**WATERTOWN
ROUTE 16 (MOUNT AUBURN STREET)**

POST DESIGN PUBLIC HEARING RENDERING
SHEET 1 OF 18

DESIGN RECOMMENDATIONS FROM PUBLIC PARTICIPATION PROCESS

POST DESIGN PUBLIC HEARING RENDERING
SHEET 9 OF 18

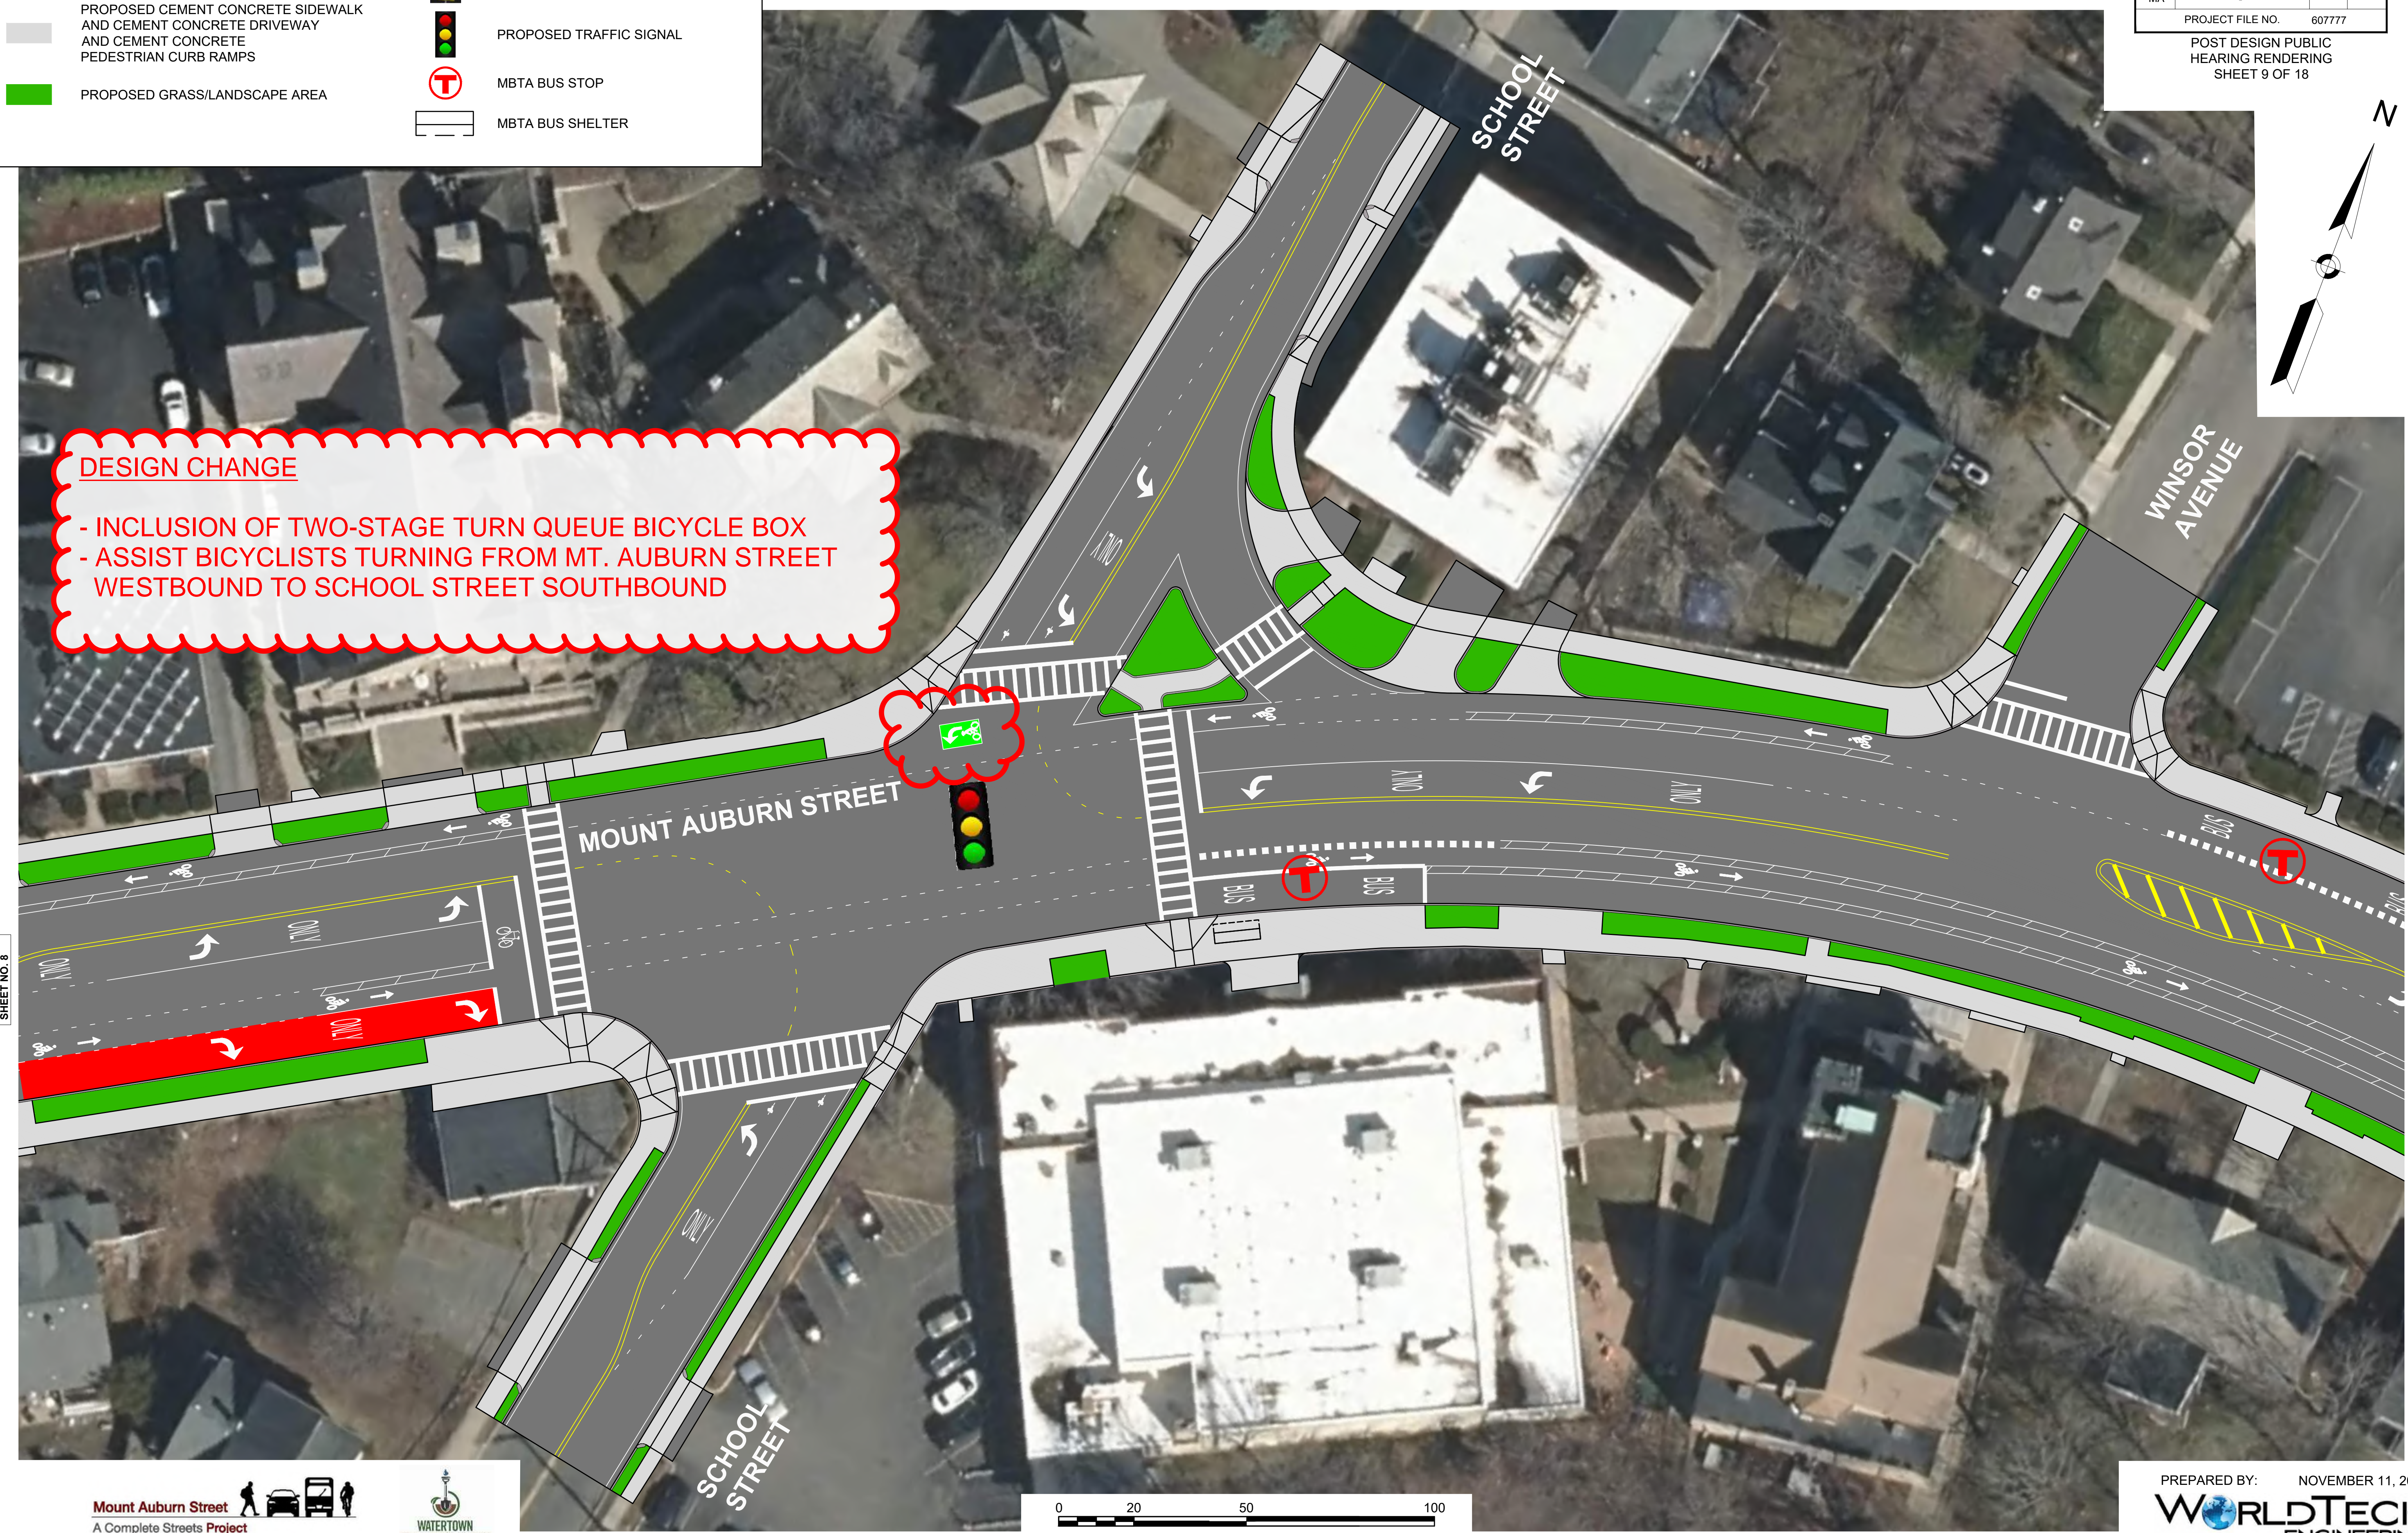
DESIGN CHANGE

- INCLUSION OF TWO-STAGE TURN QUEUE BICYCLE BOX
- ASSIST BICYCLISTS TURNING FROM MT. AUBURN STREET WESTBOUND TO SCHOOL STREET SOUTHBOUND

POST DESIGN PUBLIC HEARING RENDERING
SHEET 11 OF 18

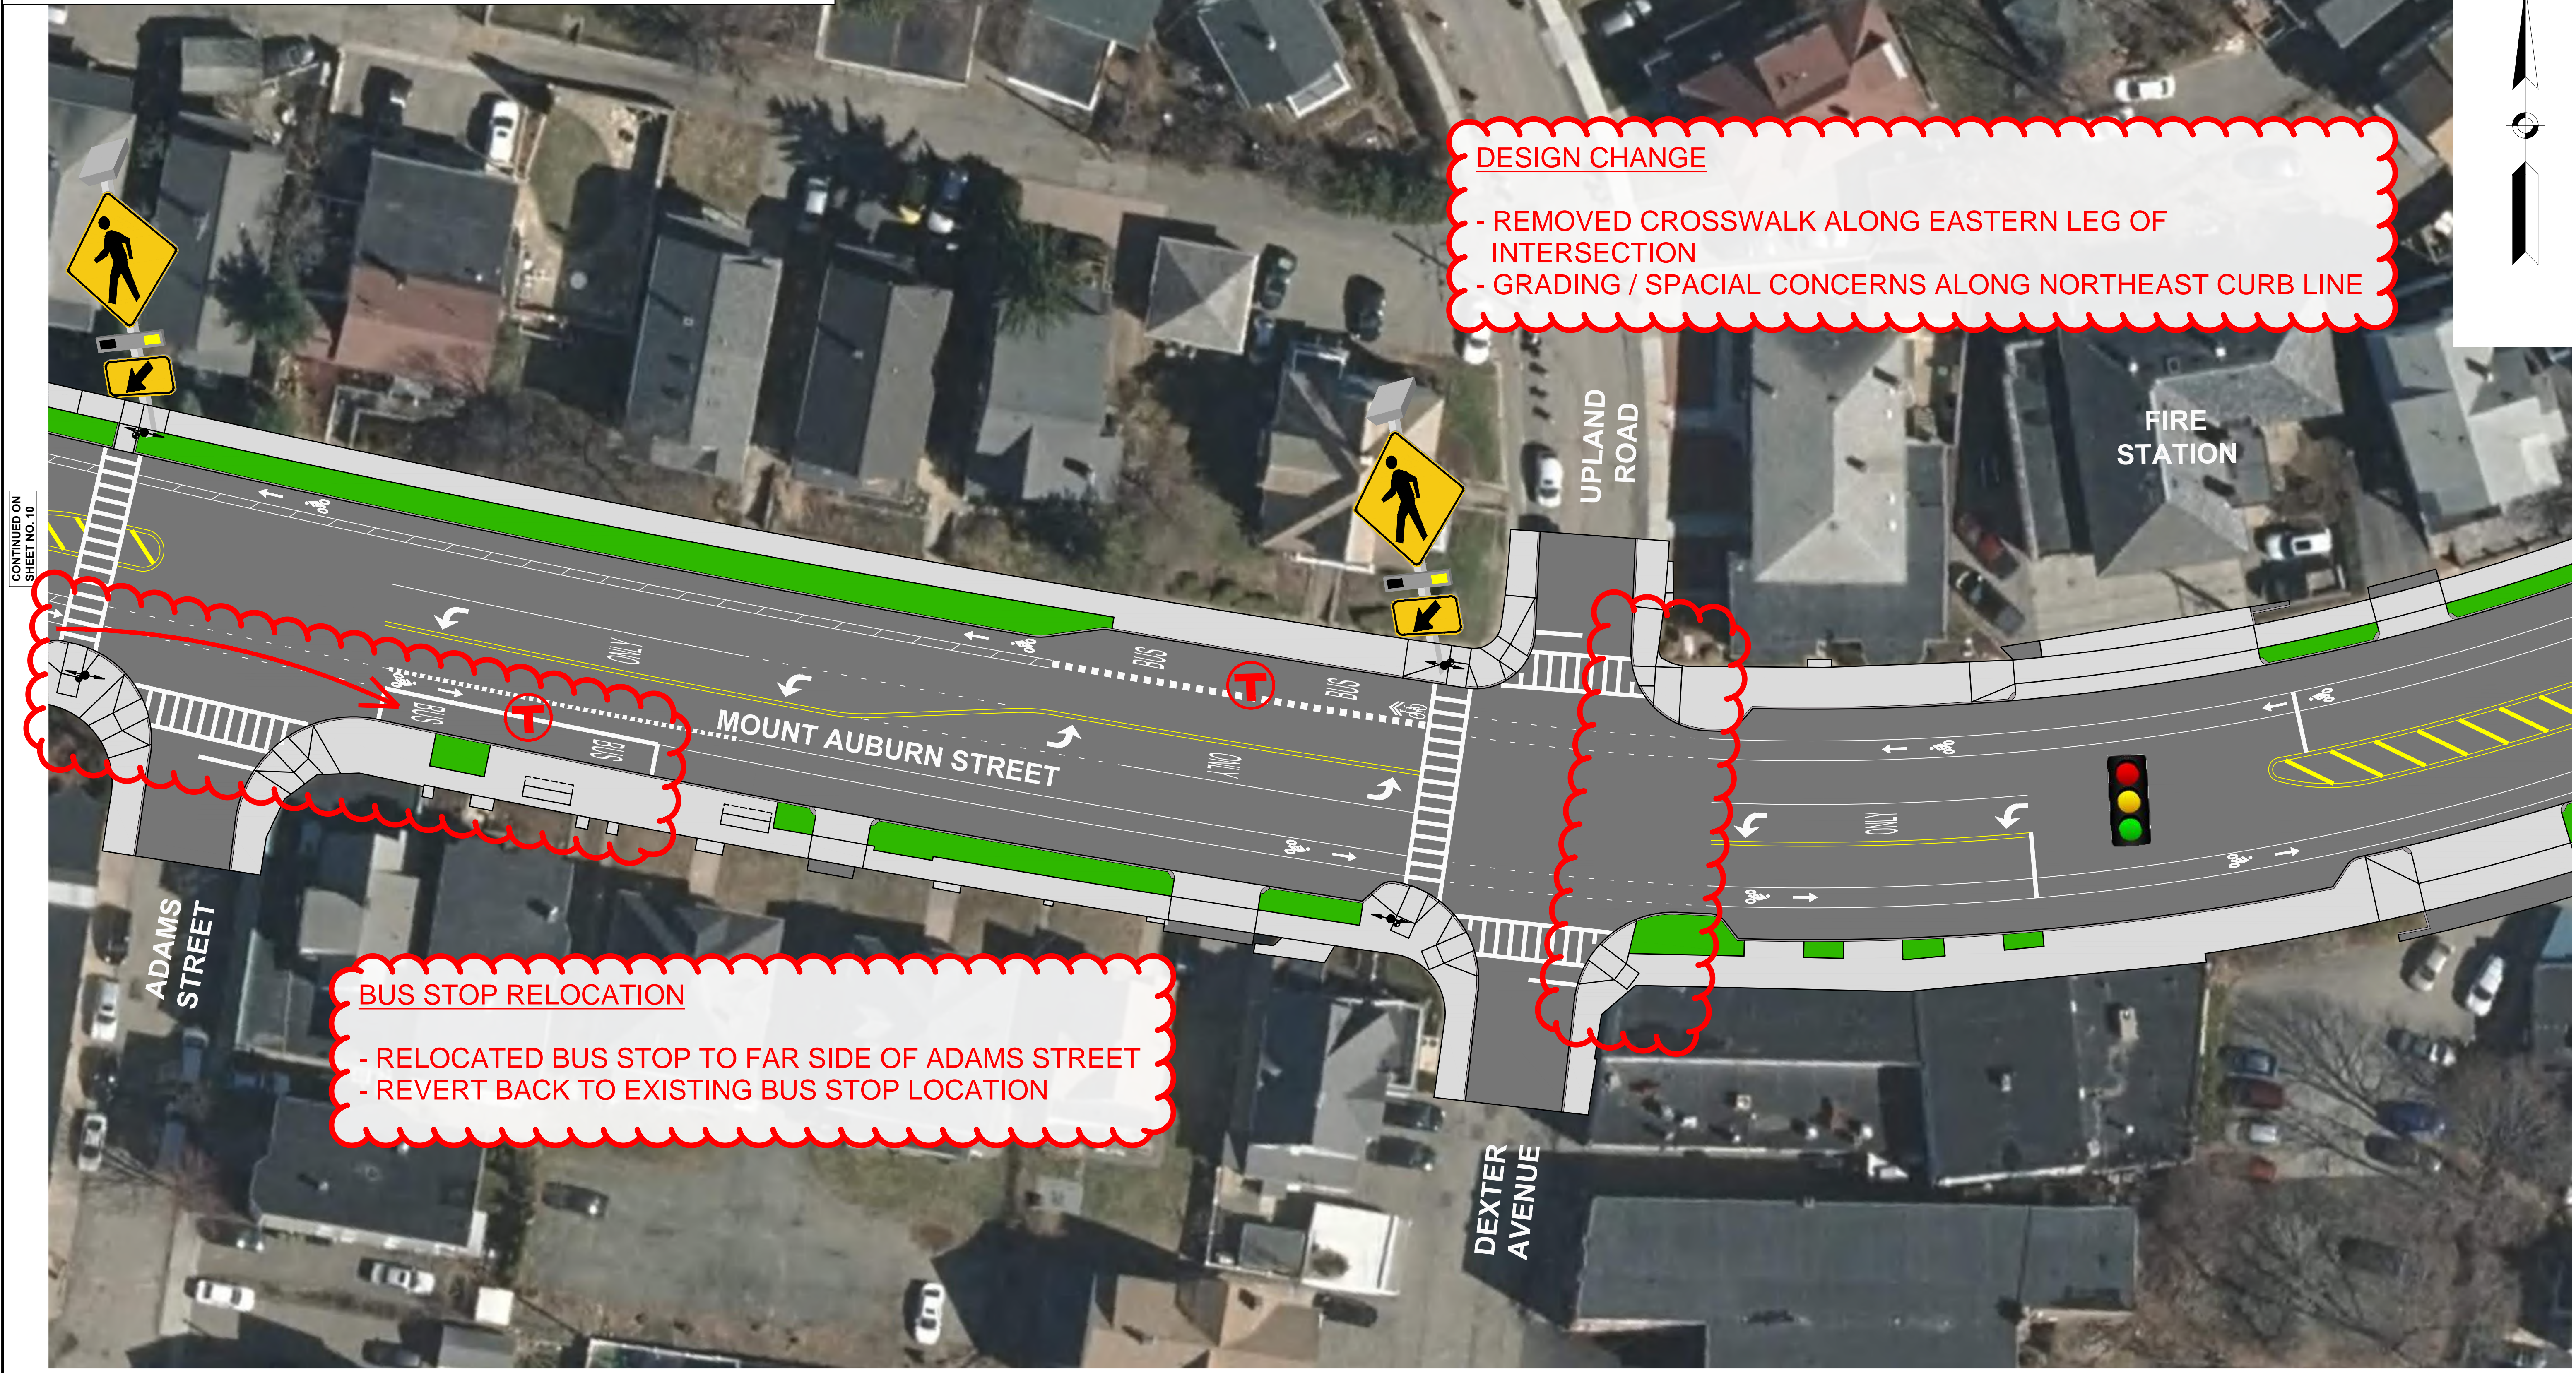
DESIGN CHANGE

- REMOVED CROSSWALK ALONG EASTERN LEG OF INTERSECTION
- GRADING / SPACIAL CONCERNS ALONG NORTHEAST CURB LINE

BUS STOP RELOCATION

- RELOCATED BUS STOP TO FAR SIDE OF ADAMS STREET
- REVERT BACK TO EXISTING BUS STOP LOCATION

POST DESIGN PUBLIC HEARING RENDERING
SHEET 12 OF 18

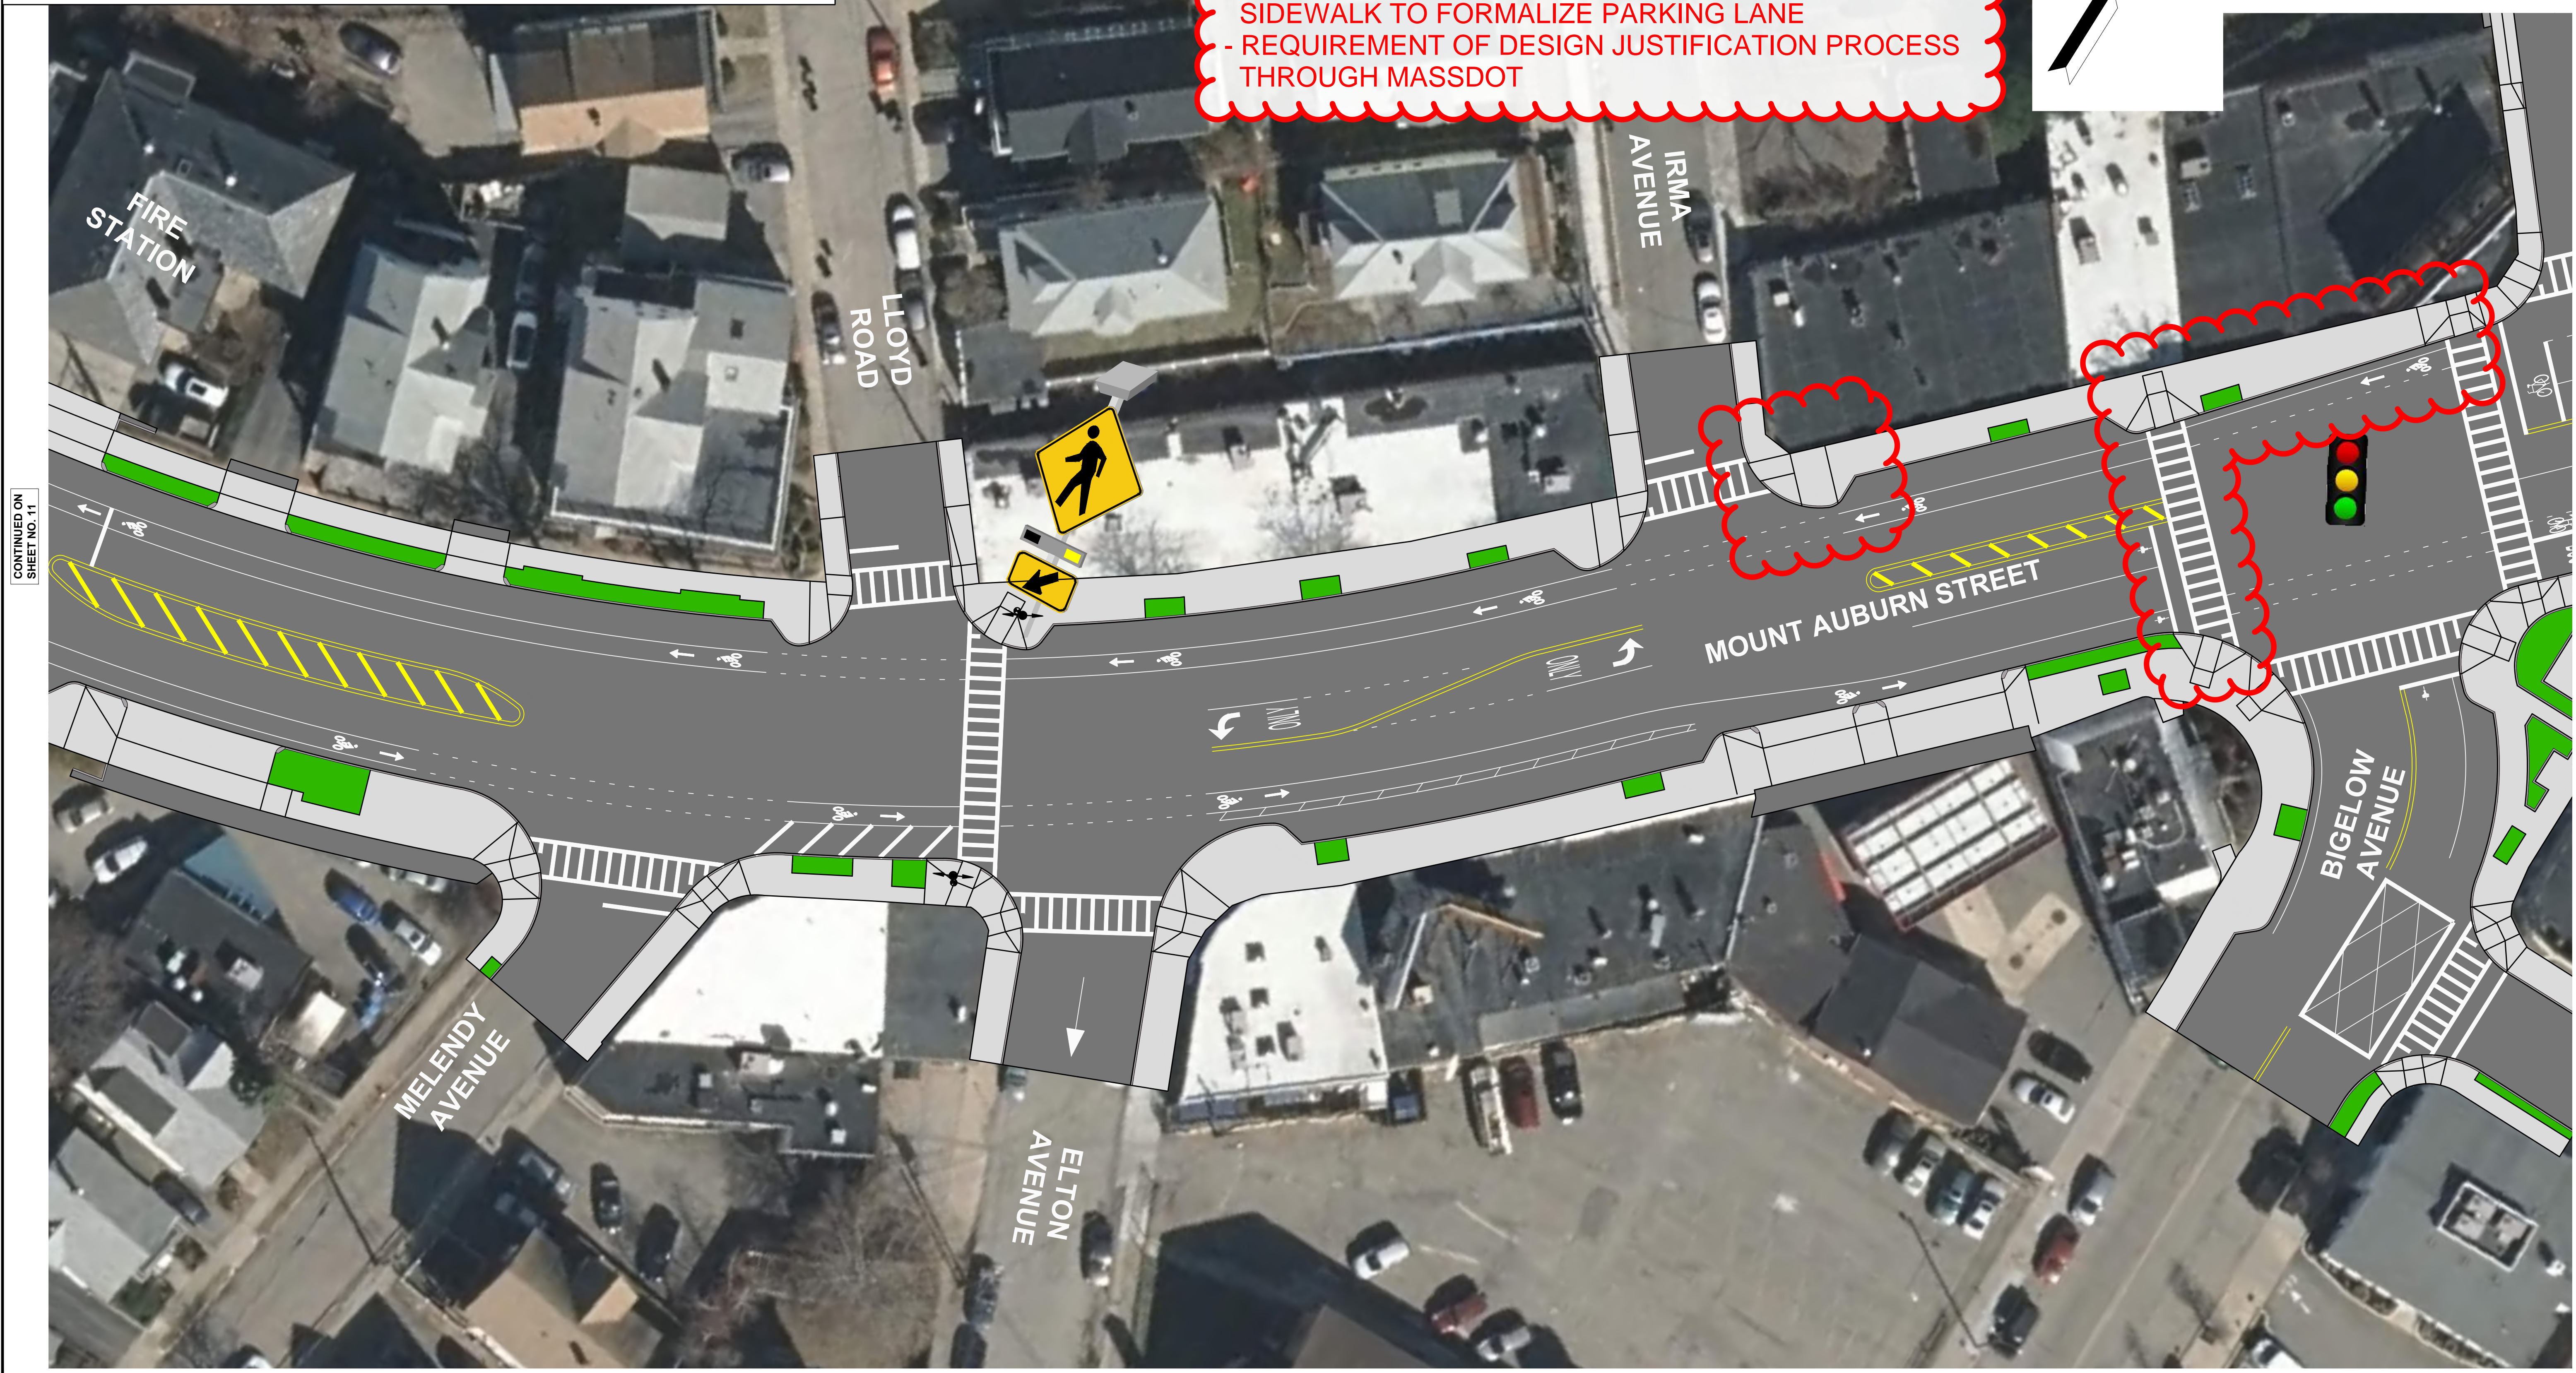
ADDITION OF MARKED CROSSWALK

- CROSSWALK ADDED TO THE WESTERN LEG OF THE SIGNALIZED INTERSECTION
- CURB EXTENSION ADDED ALONG THE WESTBOUND SIDEWALK TO FORMALIZE PARKING LANE
- REQUIREMENT OF DESIGN JUSTIFICATION PROCESS THROUGH MASSDOT
